From: Mess, Camie
Sent: Wednesday, December 19, 2018 1:24 PM
To: 'andrew@formworkusa.com'; Robert@formworkusa.com
Cc: Werner, Jeffrey B
Subject: 550 East Water Street

BAR 18-12-03
550 East Water Street
Tax Parcel 530162300
550 East Water LLC, Owner/ Robert Nichols, Applicant
Addition of overhead canopy

Addition of overhead canopy at NW entrance

550 WATER STREET / CANOPY & SIGNAGE AT WEST ENTRANCE NORTH ELEVATION

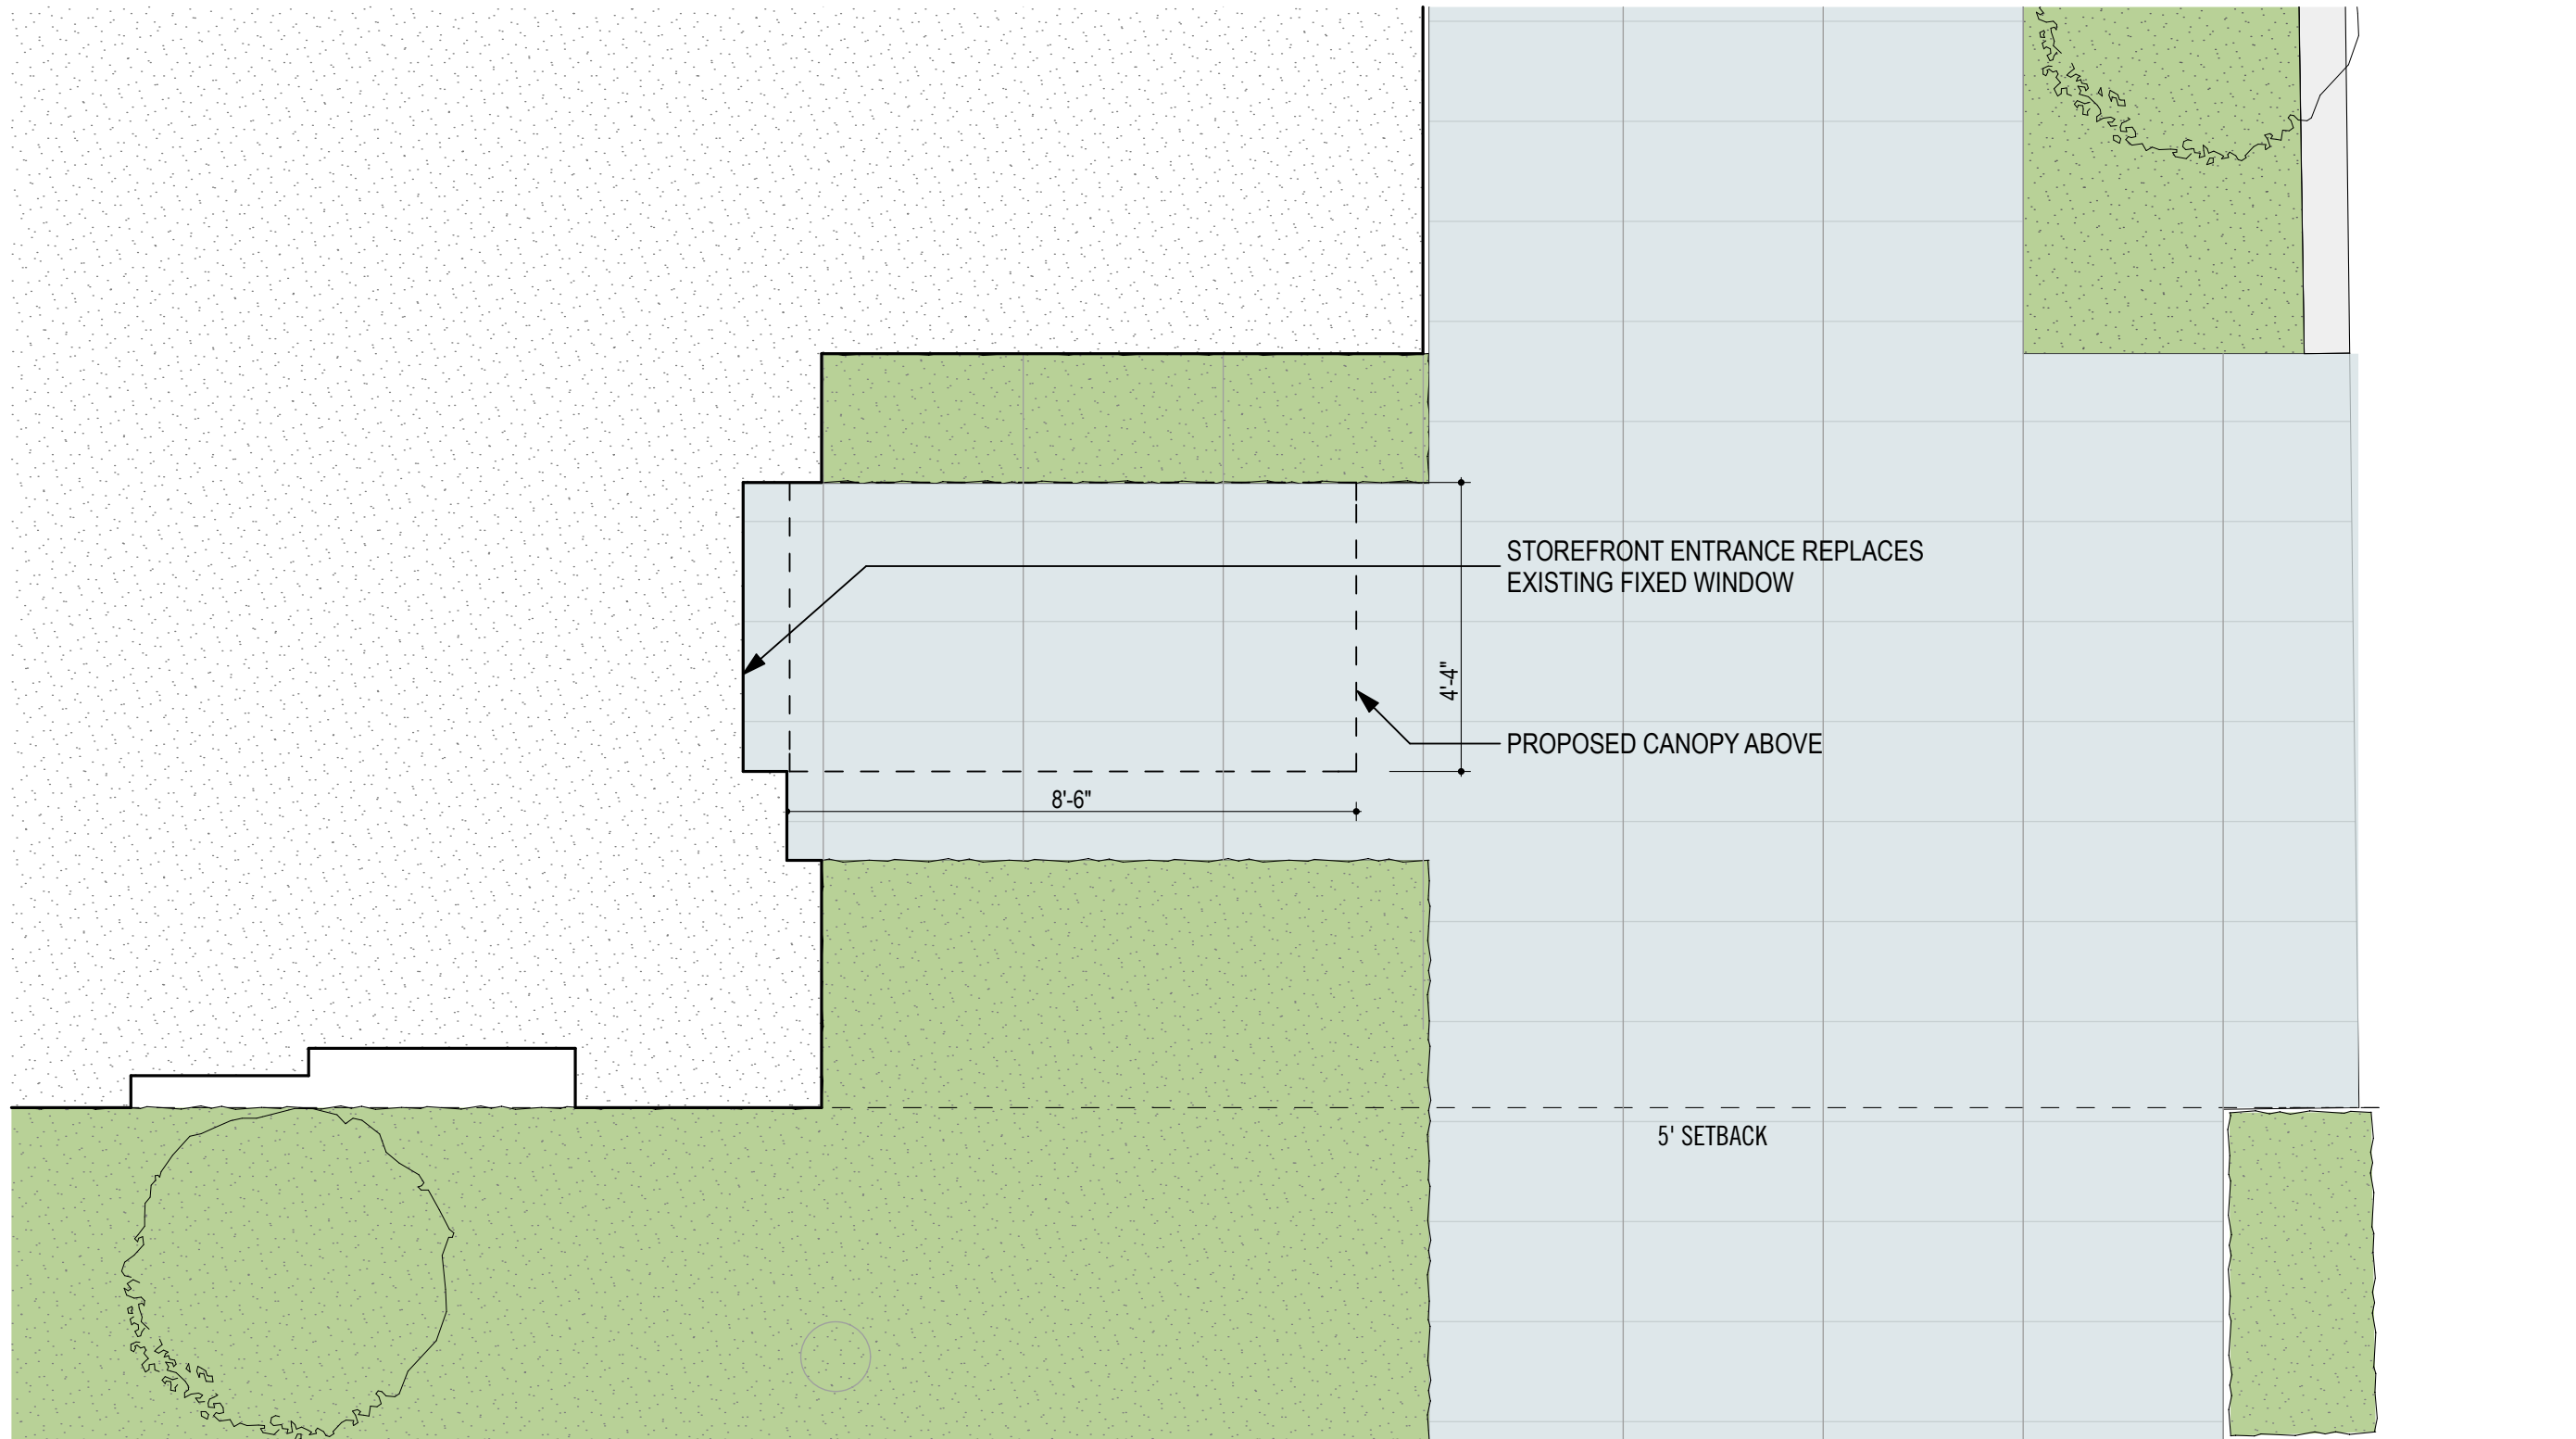
Install aluminum-clad, 8' 6" by 4'-4", cantilevered canopy over northwest entrance. Cladding to match the Water Street main entrance canopy; underside will be metal, painted white. Canopy edge (facing

Water Street) will have signage panel with painted, dimensional letters illuminated from above by recessed, dimmable, LED lighting strip.

Staff finds that the proposed canopy is appropriate for the Downtown ADC district and appropriately conforms to the existing building's architectural concept and materiality.

Motion: Schwarz having considered the standards set forth within the City Code, including the ADC Design Guidelines for Signs, Awnings, Vending and Cafes, I move to find that the proposed canopy and, in concept only, the proposed signage (as submitted or with channel lettering) satisfy the BAR's criteria and are compatible with this property and other properties in the Downtown ADC District, and that the BAR approves the application as submitted. Earnst seconded. Approved (8-0.)
